Access Compliance Report Public Rights-of-Way (Curb Ramps)

Main Street: PURDY_ST Cross Street: ELVIRA_AVE Location: NE

ADA ID: RPRK211005135205 Ramp Type: Type 1 - Perpendicular Diagonal Initial Pass/Fail: Fail Overall Compliance: No Severity Score: 16

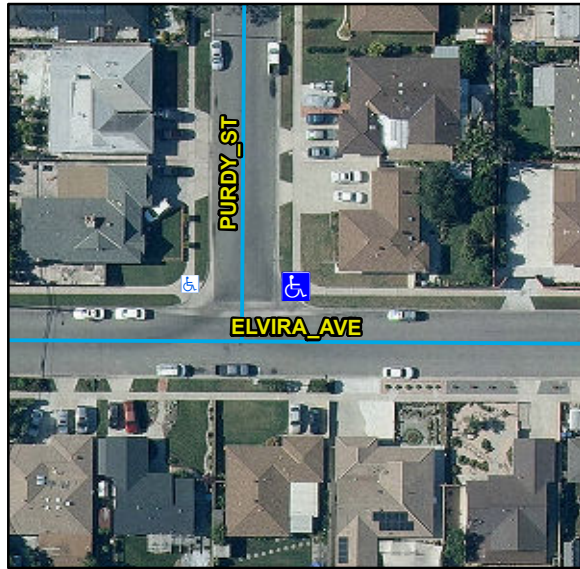
Compliance	Description	Data	Compliance	Description	Data
N/A	Ramp Length (in)	103	N/A	Flare Type LT	
Yes	Ramp Width (in)	48			N/A
No	Ramp Run Slope (%)	11.5	N/A	Flare Slope LT (%)	N/A
Yes	Ramp Cross Slope (%)	1.4	N/A	Flare Traversable LT	N/A
N/A	Landing Present	N/A	N/A	Flare Type RT	
N/A	Landing Length (in)	N/A			N/A
N/A	Landing Width (in)	N/A	N/A	Flare Slope RT (%)	N/A
N/A	Landing Run Slope (%)	N/A	N/A	Flare Traversable RT	N/A
N/A	Landing Cross Slope (%)	N/A	N/A	DWS Provided	N/A
N/A	Landing Movement Obstructed?	N/A	N/A	DWS Contrast	N/A
	Landing Movement Type	N/A	N/A	DWS Length (in)	N/A
N/A	Landing Shared	N/A	N/A	DWS Full Width	N/A
N/A	Clear Space	Yes	N/A	DWS Offset Left (in)	N/A
N/A	Clear Space To Crosswalk (in)	N/A	N/A	DWS Offset Right (in)	N/A
N/A	Marked Crosswalk 1	No	N/A	Marked Crosswalk 2	No
	Crossing 1 Direction	W		Crossing 2 Direction	S
	Marked Crosswalk 1 Width (in)	N/A		Marked Crosswalk 2 Width (in)	N/A

Remove & Replace Curb Ramp With Two New Directional Ramps or Equivalent.
